***Partial Revisions to the Application Document for Approval to Amend the Implementation Plan Regarding the Handling of ALPS Treated Water [Overview]**

April 28, 2022

Tokyo Electric Power Company Holdings, Inc.

* This application is to make a partial revision to the application for amendment related to design, facilities and dose assessment, submitted in December 2021. An additional revision on other parts in the implementation plan will be submitted at a later stage for NRA's examination.

4-4. Major Changes and additions

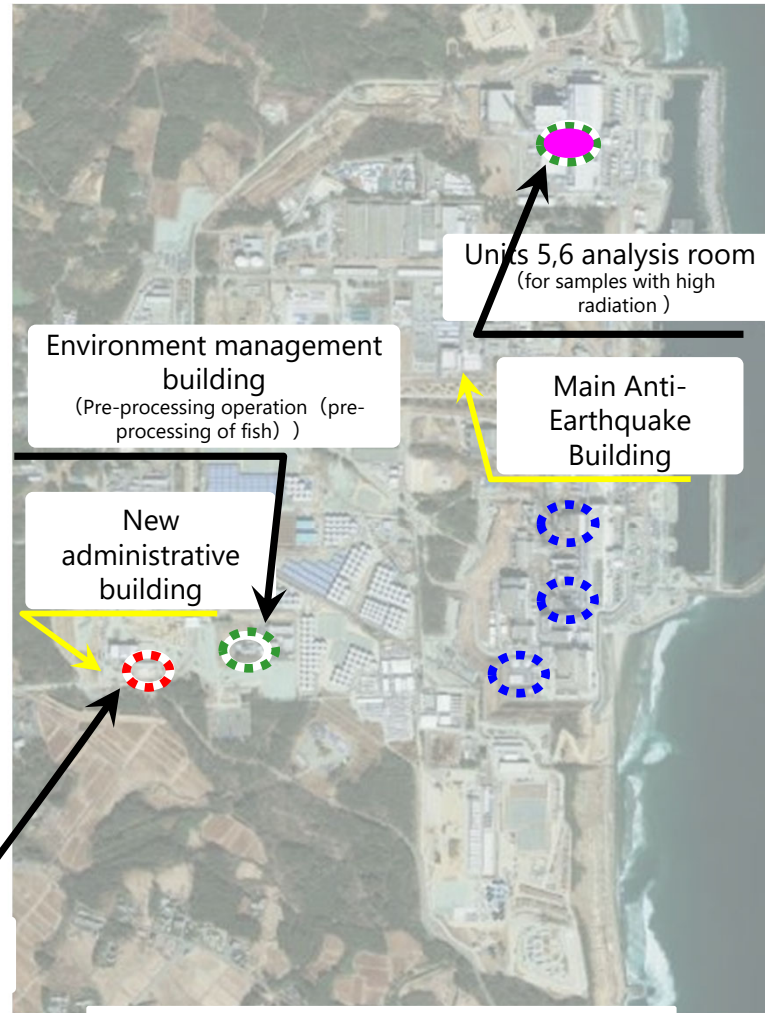
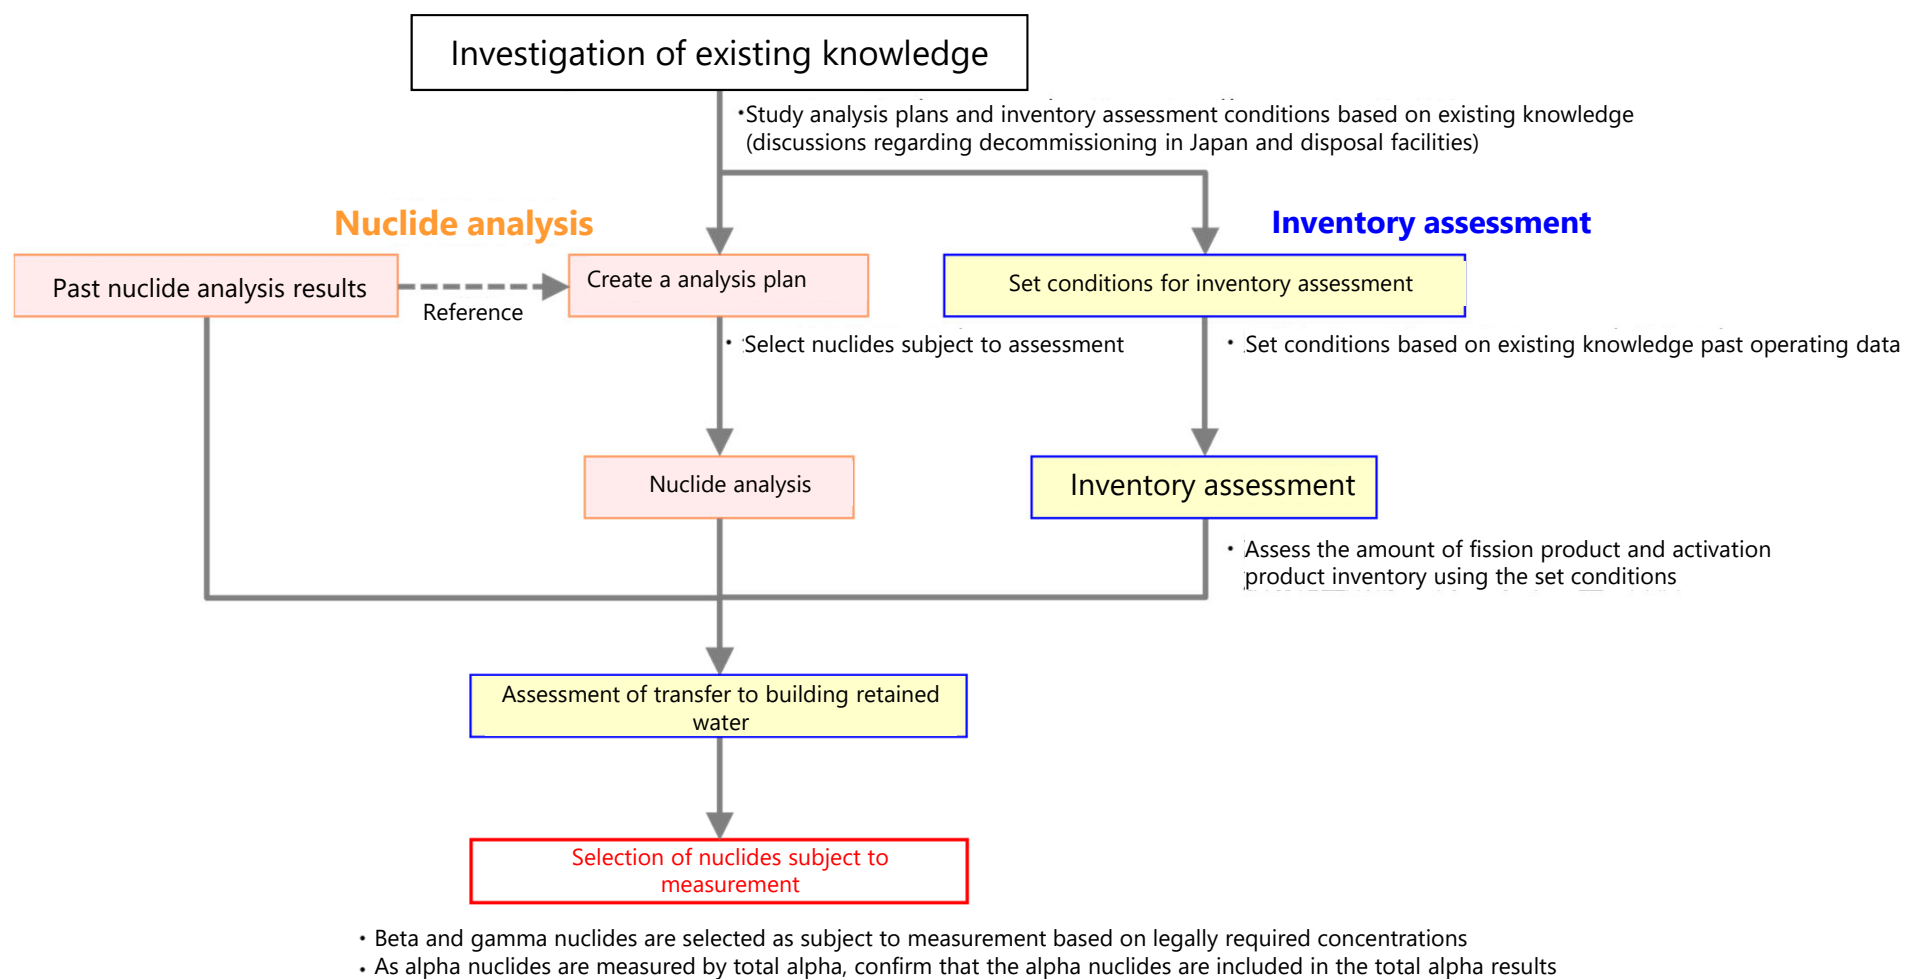
- ALPS treated water analysis methods, structure
 - Clarified the resources necessary for analysis (analysis devices, personnel, etc.) and the structures necessary to perform the analysis, analysis methods and matters to be implemented to secure objectivity and capability.

4-6. Major Changes and additions

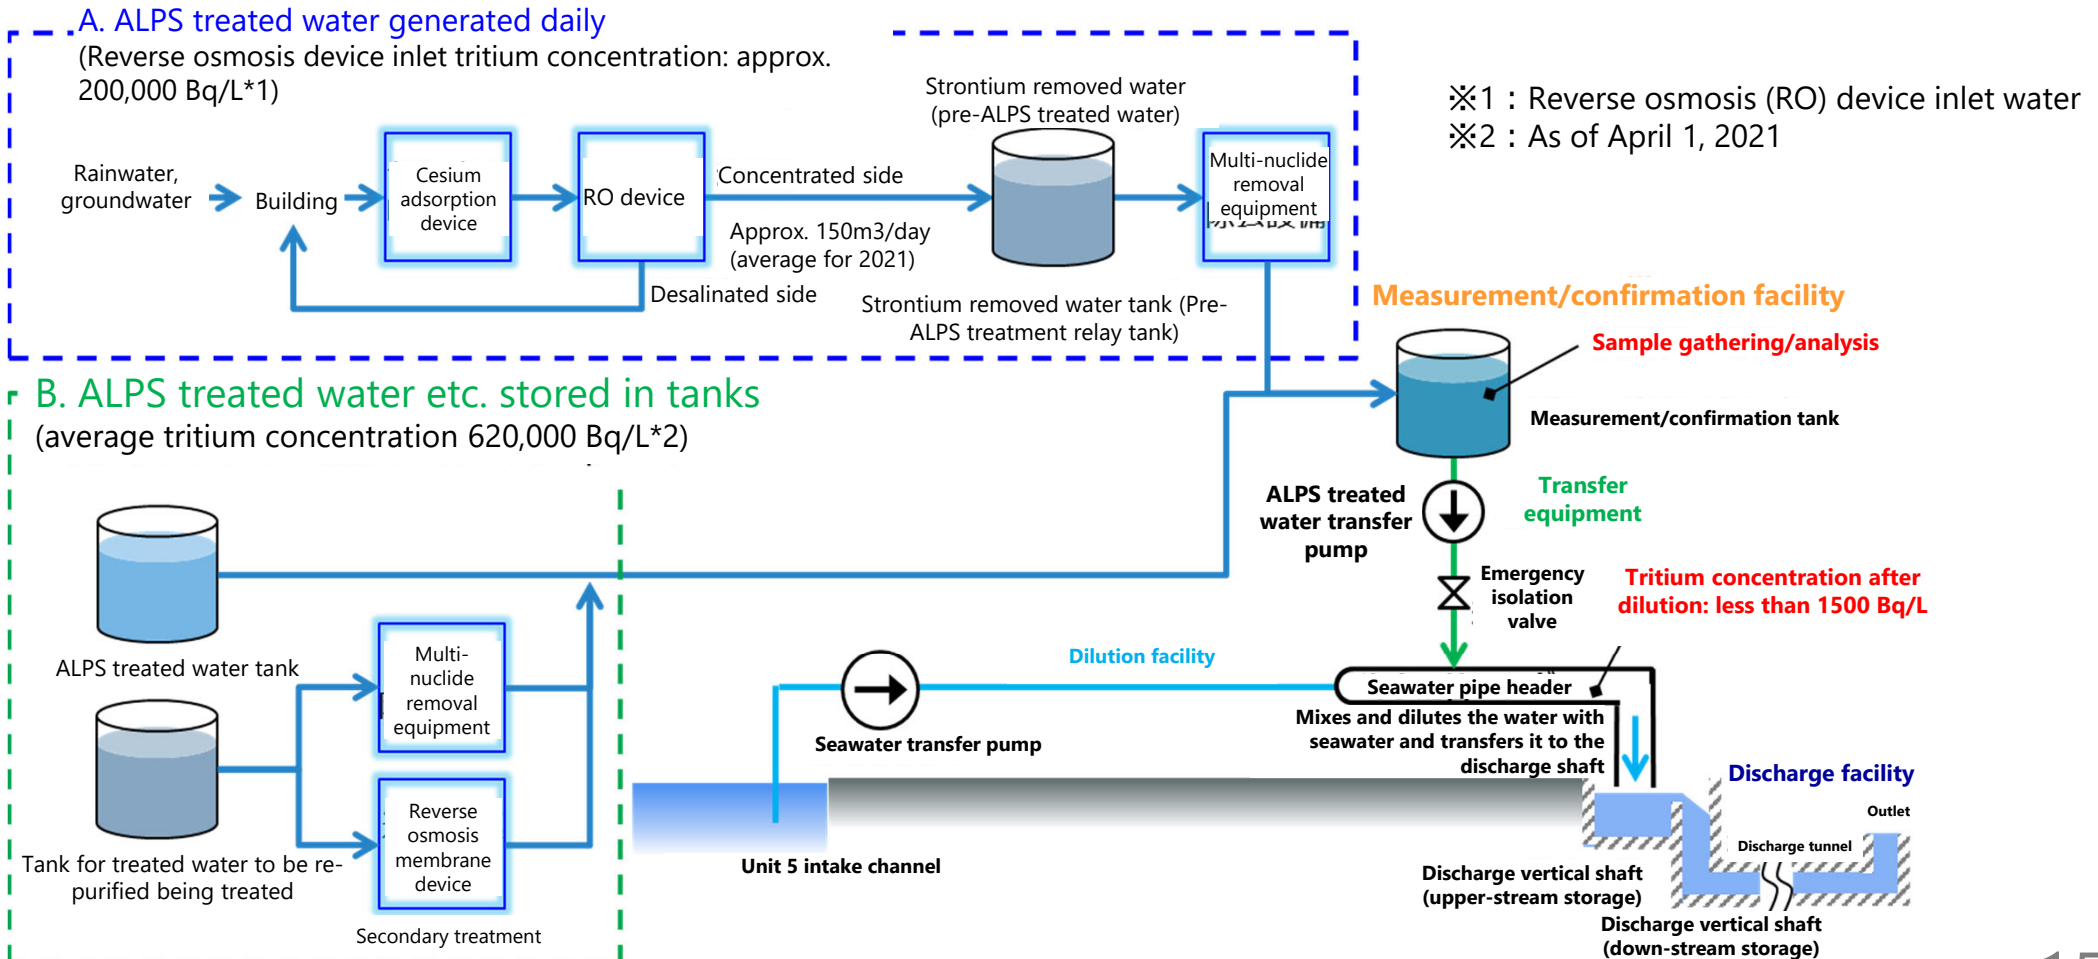
- Management of the annual amount of tritium discharged
 - ALPS treated water to be discharged is comprised of A. ALPS treated water generated daily, B. ALPS treated water, etc. stored in tanks. The basic policy is to discharge ALPS treated water starting with the water with the lower tritium concentration. The application was amended to include the tritium water management policy whereby ALPS treated water is discharged (A below) and then ALPS treated water is discharged at amounts that do not exceed 22 trillion Bq/year (B below).
